CLIENT
CHARLES CHURCH

PROJECT
SKETCHLEY LANE BURBAGE

TITLE
EXTERNAL LEVELS SH2 OF 4

PROJECT NO. 23053	DRAWING NO. 111	REV U
----------------------	--------------------	----------

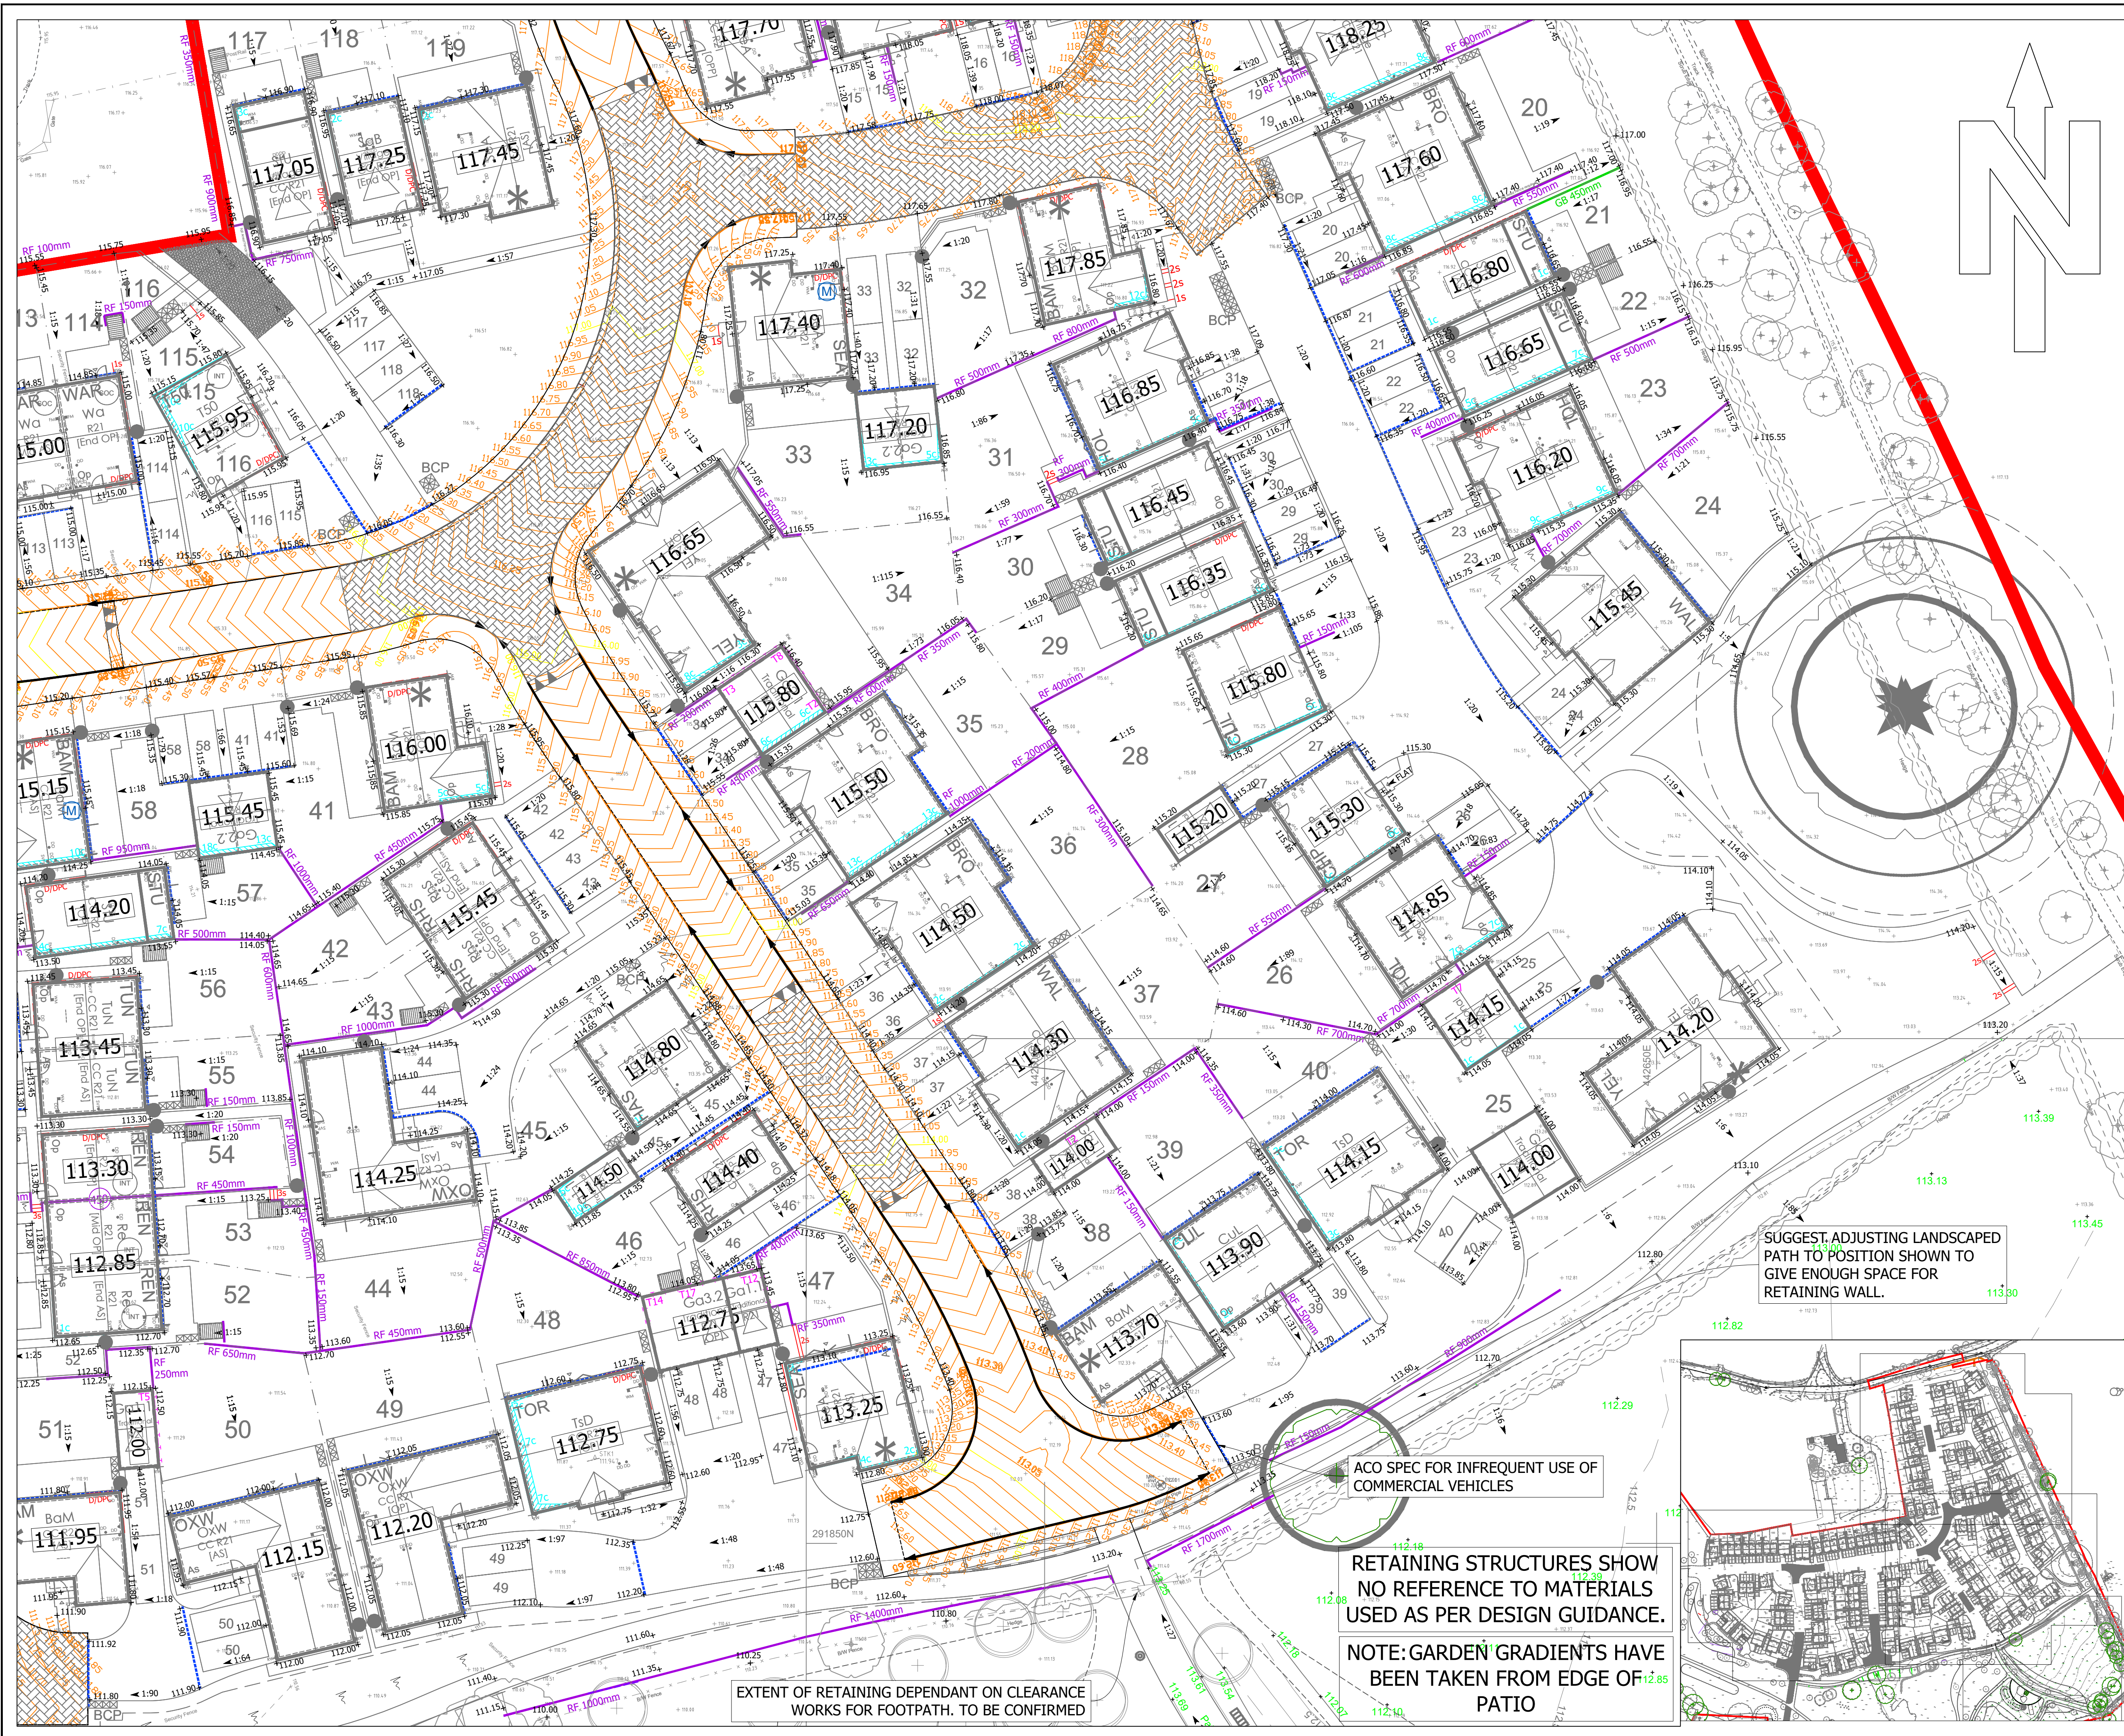
SUGGEST ADJUSTING LANDSCAPED PATH TO POSITION SHOWN TO GIVE ENOUGH SPACE FOR RETAINING WALL.

ACO SPEC FOR INFREQUENT USE OF COMMERCIAL VEHICLES

RETAINING STRUCTURES SHOW NO REFERENCE TO MATERIALS USED AS PER DESIGN GUIDANCE.

EXTENT OF RETAINING DEPENDANT ON CLEARANCE WORKS FOR FOOTPATH. TO BE CONFIRMED
